ALIGO ASSEMBLY DRAWING

aLIGO OpLev ITM/ETM Breadboard

AUTHOR(S)	DATE	Document Change Notice, Release or Approval
Eric James	26 June, 2012	see LIGO DCC record Status

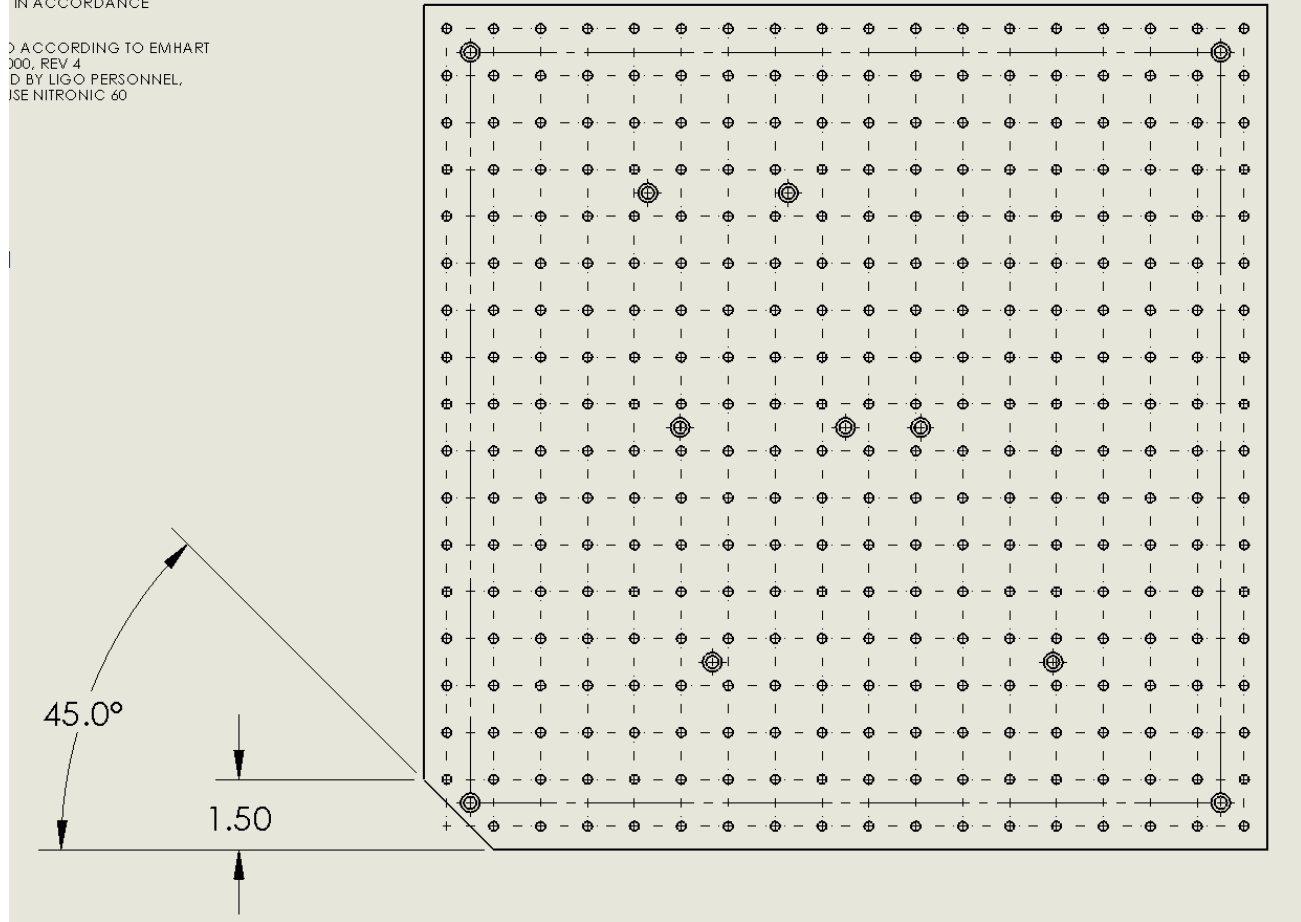
ITM Breadboard modification. Left hand version shown. Counterbored holes need to be enlarged to accommodate a 5/16" socket head cap screw ($\phi 0.332$ thru, c'bore $\phi 0.531$ 0.313 deep). See earlier version for original hole locations.

aLIGO OpLev ITM/ETM Breadboard

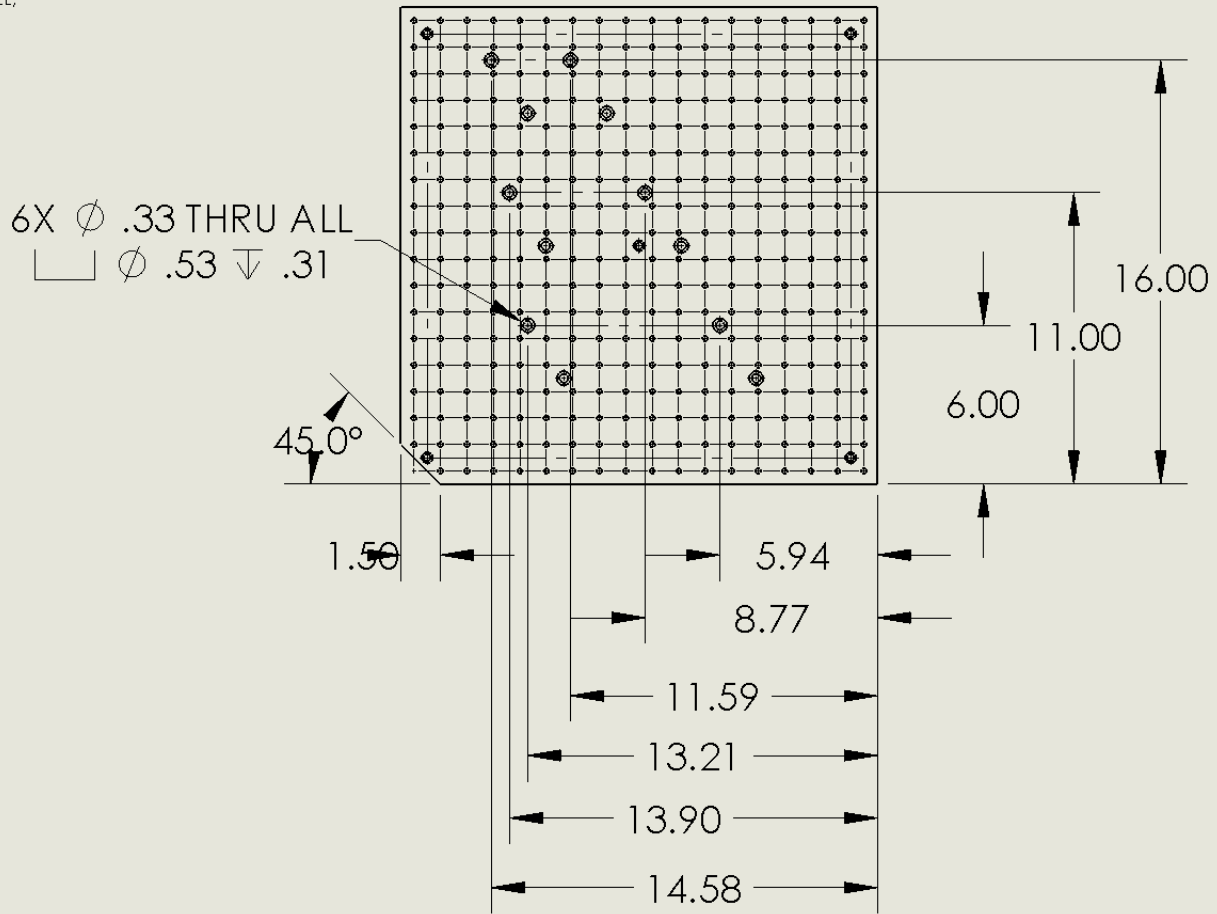
ETM Breadboard modification. Left hand version shown. Six counterbored holes need to be added to accommodate change in pylon location for the photon calibrators.
